File No: SP 23-05 Northwest RE LLC Industrial Project

Summary: On February 6, 2024, the Millersburg Planning Commission held a public hearing for the project. The Commission approved the Site Development Review application with the conditions of approval listed in the staff report. The Commission found that all criteria and standards were met based on the accepted facts and the conditions of approval. The Commission relied on facts from the staff report, the applicant's materials, and the City's Comprehensive Plan, Codes, and Ordinances as provisions for the basis of their decision. No changes were made to the proposed conditions of approval and no additional conditions were added.

Proposal: The application is for a Site Development Review of a single building with 326,285 SF of manufacturing space, 17,300 SF of office space, and 156,425 SF of warehouse space. The total building size is estimated to be 500,010 SF. The primary purpose of the building is manufacturing with the designated warehouse and office uses being accessory uses. The site also features passenger vehicle and truck parking areas, landscaping, water quality basins, truck maneuvering areas, loading bays, and an un

SITE PLAN

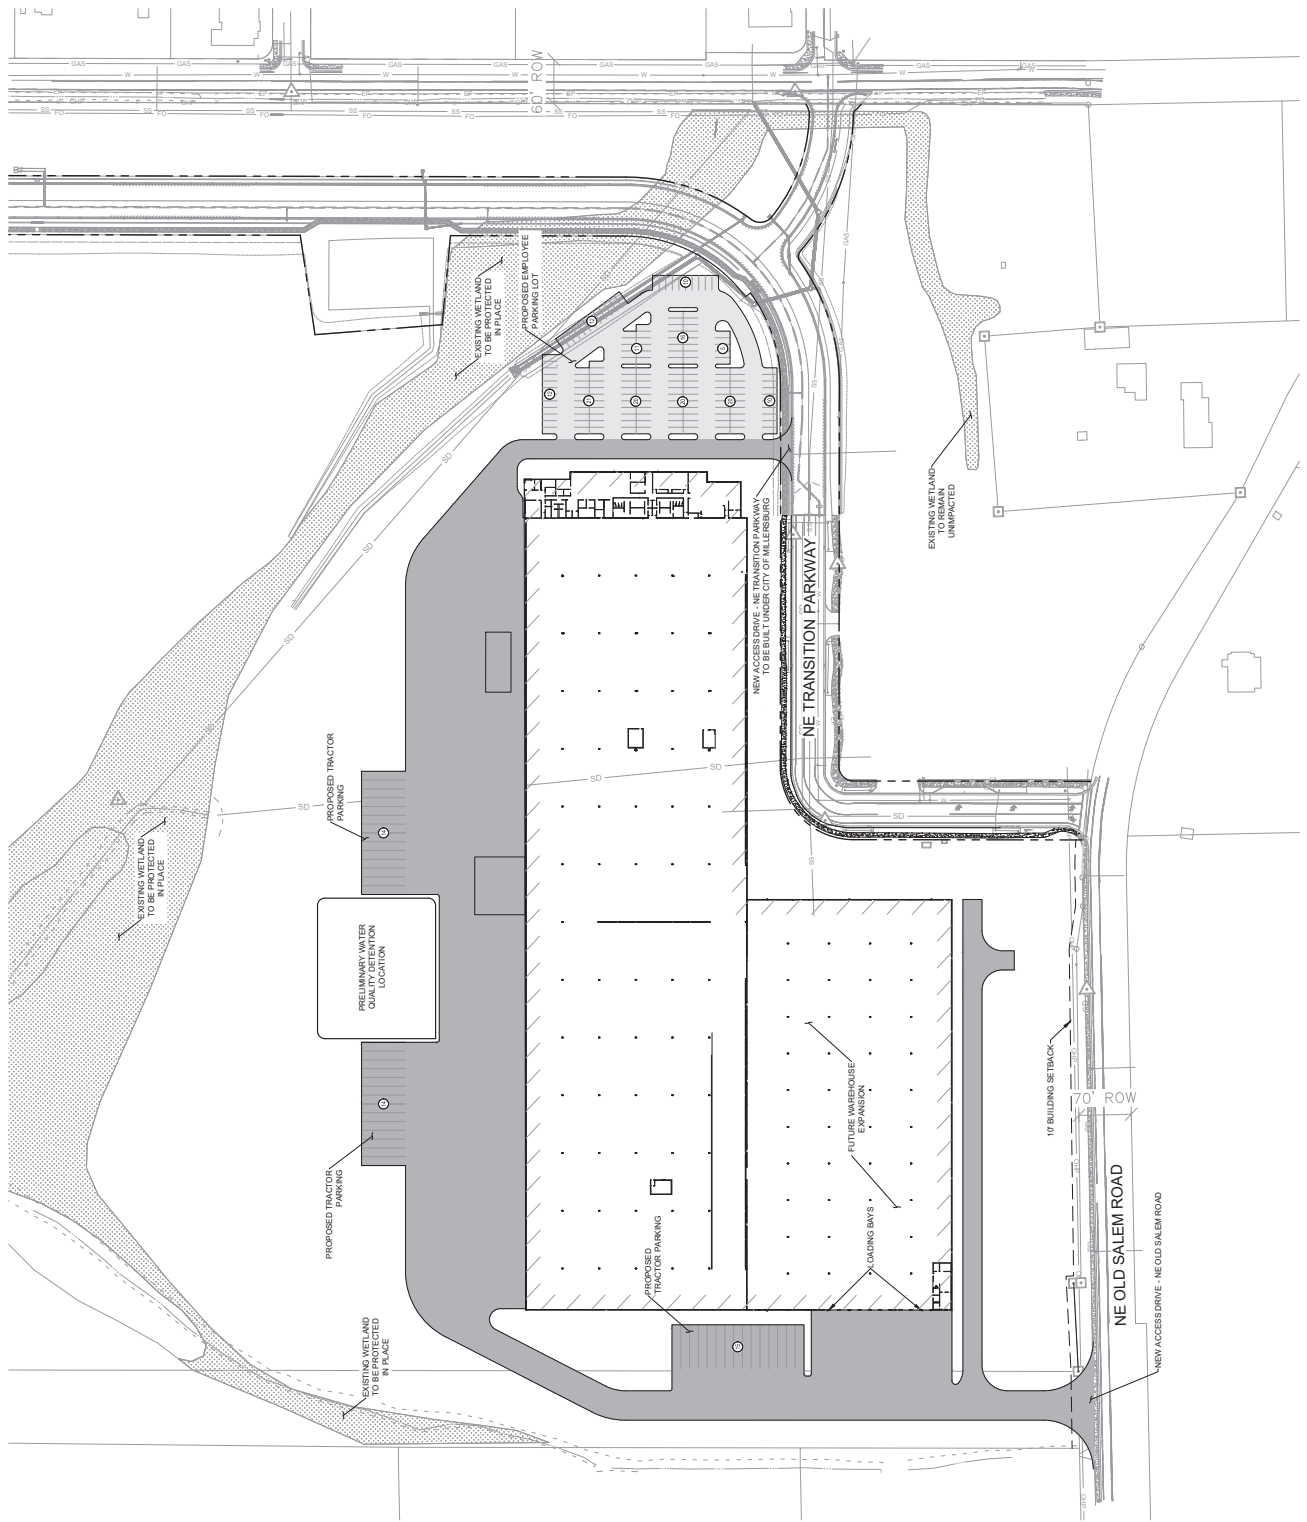
are not required. Sidewalks connecting the building to the parking lot and to the street are not shown. A condition of approval has been added to require the applicant to show these on the final site plan. The site plan shows large truck maneuvering areas that will provide ample room for safe large truck turns internal to the site. The application has shown that it will be safe by meeting the standards in the development code. With the standards met, there should be no issues with traffic safety.² The applicant has also explained in the narrative:

12. Prior to building permit issuance, all lighting plans must be reviewed and approved by staff to assure compliance with the standards found in the Millersburg Development Code Section 3.03.080(4).
13. Prior to the issuance of building permits, subdivision SD 23-01 shall be recorded.
14. Prior to the issuance of a building permit the applicant shall provide a revised site plan showing sidewalks connecting the structure to the parking area and to the sidewalks along the street.
15. Prior to the issuance of a building permit, the Applicant shall obtain access permit from Linn County for the access on NE Old Salem Road.
16. Prior to the issuance of a building permit the applicant shall provide a revised site plan showing sidewalks connecting the structure to the parking area and to the sidewalks along the street.

LANDSCAPE PLAN

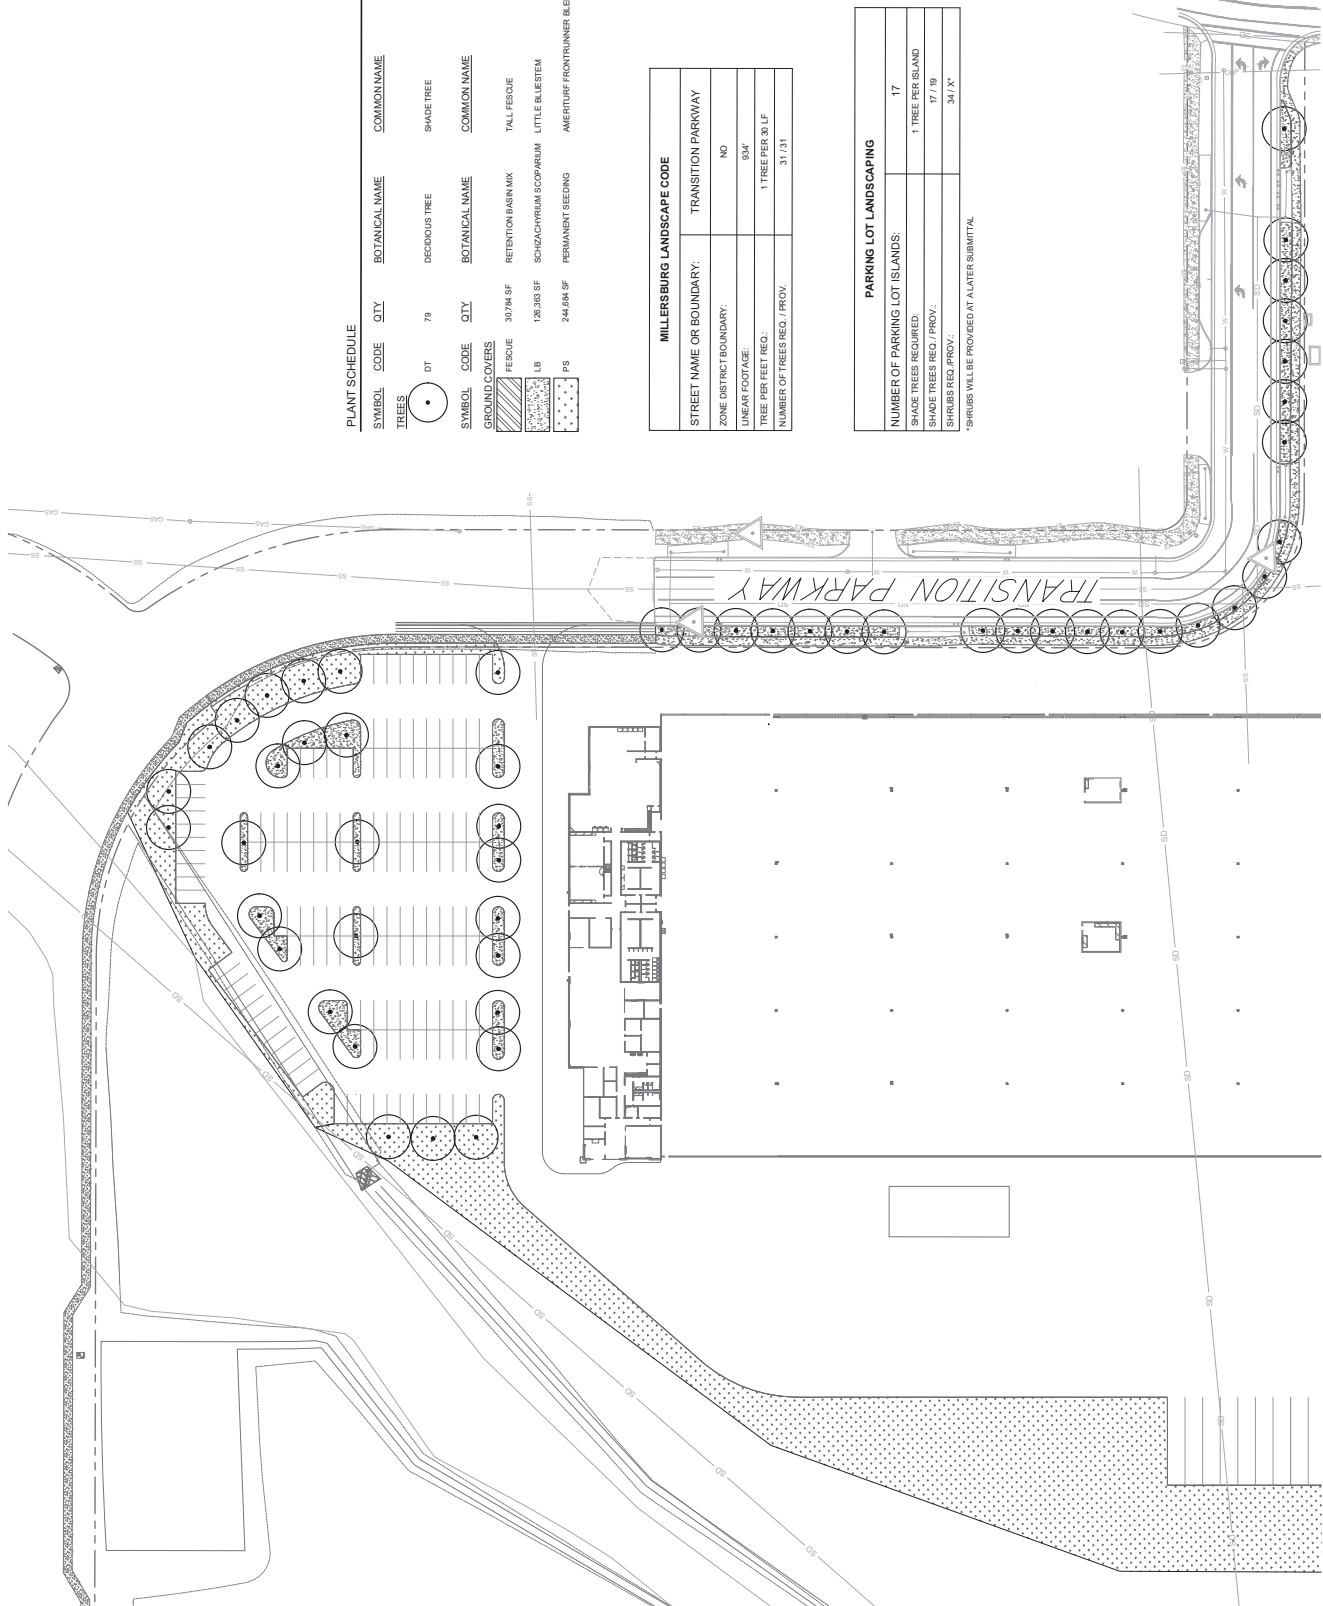
Landscaping is included within the proposed parking lot and along the site frontage for NE Transition Parkway. Trees are proposed every 30 linear feet for the 934 feet of frontage, with a total of 31 trees proposed. Following the requirement of one shade tree per parking lot island, the proposed employee parking lot has 17 islands, for a total of 17 shade trees required and 19 shade trees proposed, exceeding the minimum standard. Shrubs will be provided in later iterations of the Landscape Plan.
